# NOTICE OF DECISION

## DECISION OF THE HEARINGS OFFICER

### CONDITIONAL USE / SUBDIVISION TENTATIVE PLAN / CLASS 2 ADJUSTMENT / CLASS 2 DRIVEWAY APPROACH PERMIT CASE NO.: CU- SUB-ADJ-DAP22-05

## WALN CREEK CROSSING

TENTATIVE SUBDIVISION PLAN  
DETAIL PLAN

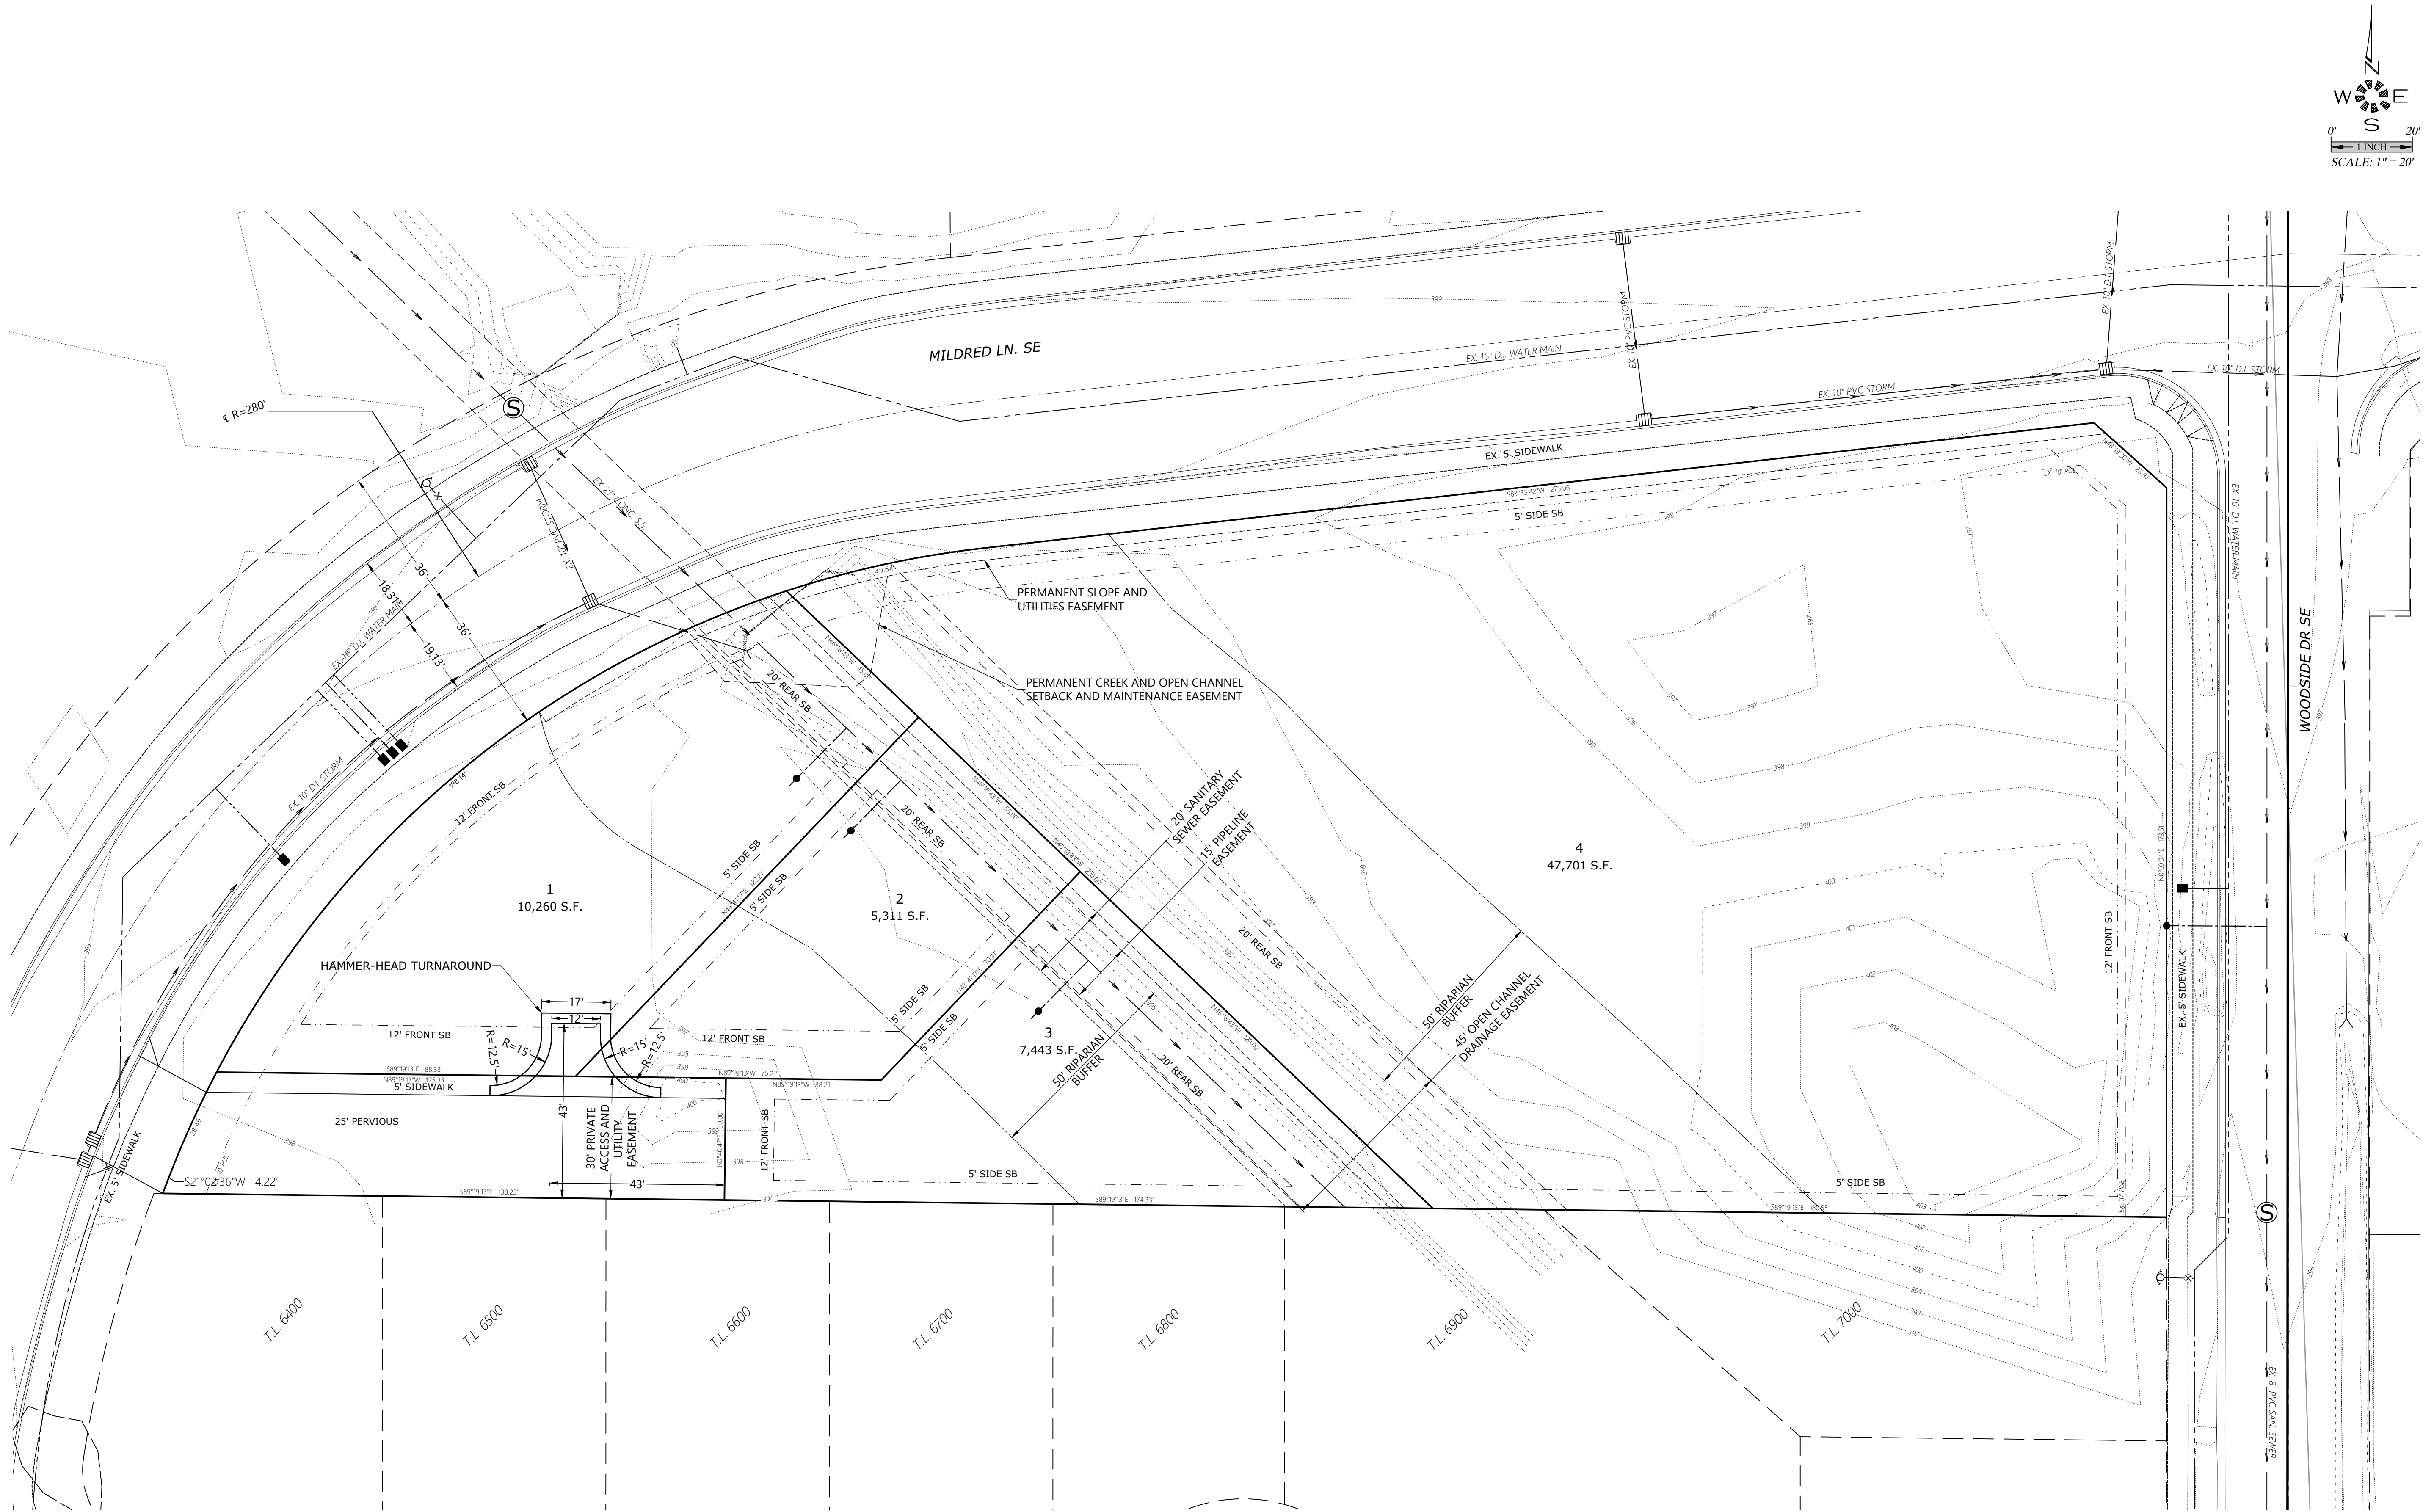
However, as shown on the tentative subdivision plan, the applicant has identified the south property line of Lot 1 abutting the flag lot accessway as the front, rather the west property line abutting Mildred Lane. The subdivision designates the south property line of Lot 1 as the front in order to provide a more developable building envelope on the lot in relation to required setbacks and to be consistent with the front lot line designation of abutting Lot 2 to the south.

As shown on the tentative subdivision plan, the proposed flag lot accessway serving Lots 1-3 conforms to the requirements of SRC 800.025(c). The accessway does not serve more than four lots, it doesn't exceed 150 feet in length, it includes a turnaround

SRC 800.025(e) limits the maximum number of flag lots allowed within a subdivision to 15 percent. Based on the four lots proposed, the maximum number of flag lots allowed within the subdivision is one. However, as shown on the tentative subdivision plan, the proposal includes two flag lots (Lots 2 and 3). Because the number of proposed flag lots within the subdivision exceeds the maximum allowed 15 percent, the applicant has requested a Class 2 Adjustment to this standard to increase the maximum number of flag lots allowed from one to two. Analysis of the Class 2 Adjustment request and findings demonstrating conformance with the Class 2 Adjustment approval criteria are included in Section 9 of this report.

As shown on the tentative subdivision plan, two of the lots within the subdivision are proposed flag lots (Lots 2 and 3) and a total of three lots (Lots 1, 2, and 3) are proposed to be served by a flag lot accessway improved to a minimum width of 25 feet together with a 5-foot-wide sidewalk along one side and a turnaround meeting the Public Works Design Standards (PWDS).

Pursuant to SRC 804.035(c)(5), only forward in/forward out access shall be allowed onto an arterial street. The applicants tentative plan shows a hammerhead turnaround to accommodate forward in/forward out movements from the proposed accessway to Mildred Lane SE. In order to ensure the proposed driveway approach does not create traffic hazards and provides for safe turning movements and access, the following condition of approval applies:

- Condition 8:** The flag lot accessway serving Lots 1-3 shall be developed as shown on the tentative subdivision plan to include a 25-foot-wide paved width together with a 5-foot-wide sidewalk. "NO PARKING—FIRE LANE" signs shall be posted on both sides of that portion of the flag lot accessway that is a fire apparatus roadway, and "NO PARKING" signs shall be posted on both sides of any remaining portion of the accessway.

**Condition 11:** The flag lot accessway serving Lots 1-3 shall include a turnaround as shown on the tentative subdivision plan to ensure forward-in/forward-out movement onto Mildred Lane SE.

**Condition 8:** The flag lot accessway serving Lots 1-3 shall be developed as shown on the tentative subdivision plan to include a 25-foot-wide paved width together with a 5-foot-wide sidewalk. "NO PARKING-FIRE LANE" signs shall be posted on both sides of that portion of the flag lot accessway that is a fire apparatus roadway, and "NO PARKING" signs shall be posted on both sides of any remaining portion of the accessway.

**Condition 11:** The flag lot accessway serving Lots 1-3 shall include a turnaround as shown on the tentative subdivision plan to ensure forward-in/forward-out movement onto Mildred Lane SE.
